V8 XJ Series/XK

204-S499

## TECHNICAL BULLETIN

Lower Wishbone Front Bushing –  
Change Of Specification –  
Service Action S499MODEL  
1999-2000 MY XK Range  
1999-2000 MY V8 XJ Series  
VIN  
034426-A06104  
862295-F11235Remove and destroy Bulletin 204-S499, dated 04/03.  
Replace with this Bulletin.  
Revisions are marked with a bar and in **bold text**.**Issue:**

ILLUSTRATION 1

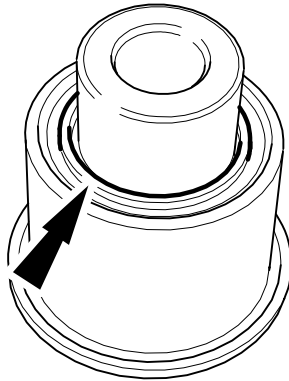
1. **Raise vehicle on ramp.**
2. **Inspect the front wishbone bushings. A raised circular rib around the circumference of the center steel core identifies the MNE 1360BB level bushing (Illustration 1).**

**Note: If the MNE 1360BB level bushing is installed, no further action is required. If any other level of bushing is installed, continue with the procedure below to install MNE 1360BB level bushings.**

ILLUSTRATION 2

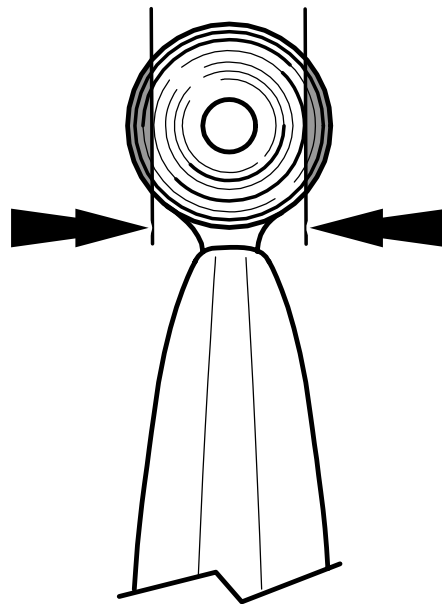
1. Disassemble the front suspension as necessary, as detailed in JTIS, Section 204, **SRO 60.35.45 for XK vehicles, SRO 60.35.56 for V8 XJ Series vehicles. If removing steel-cased bushings continue procedure with step 2 below.**
2. Make 2 saw cuts through the rubber and **partly** into the flange of the steel casing, at the locations shown in Illustration 2, in line with the casing of the bush.

**⚠ Caution:** Do **not** cut **fully** through the steel flange. The sawcuts should penetrate through only 75 - 80 % of the thickness of the steel flange, so that the saw blade does not contact the wishbone arm.

3. Use a hammer and chisel, or similar hand-tool, to bend the 'half-moons' of the flange away from the wishbone arm.

Use pliers or grips to repeatedly bend the 'half-moons' back and forth until the 'half-moons' break off along the line of the saw cuts.

ILLUSTRATION 3

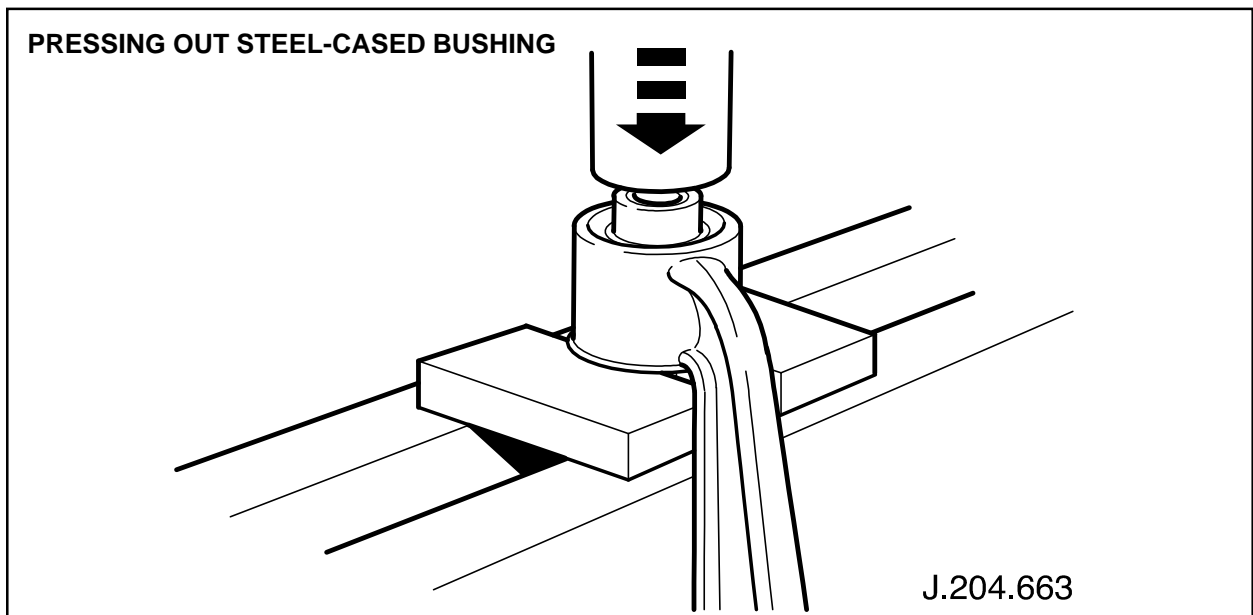
3. Position the wishbone arm on the support plates of the hydraulic press, so that the bushed end is supported by the plates where the 'half-moons' have been removed. This will allow the casing of the displaced bush to pass between the support plates (Illustration 3).

4. Using Special Tool 204-214, press the bush from the bore in the wishbone arm.
